ALDERHOLT PARISH COUNCIL

Response from Alderholt Parish Council

Application: - HCC/2024/0755

Proposed extraction of sand and gravel with associated access, internal haul roads, processing plant, silt and freshwater lagoons, stockpiles, conveyors, offices, weighbridge, and other ancillary infrastructure, creation of new permissive path, and restoration with inert materials to agriculture, amenity and nature conservation at Midgham Farm, Near Fordingbridge, Hampshire SP6 3DA

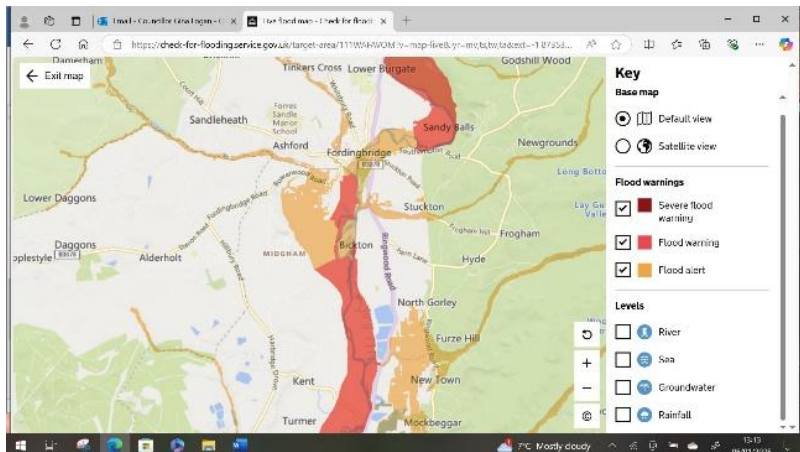
Note that Footpath E34/7 from Hillbury Road to Midgham Farm floods every wet winter together with adjoining fields that make up the site, as shown in the photos above.
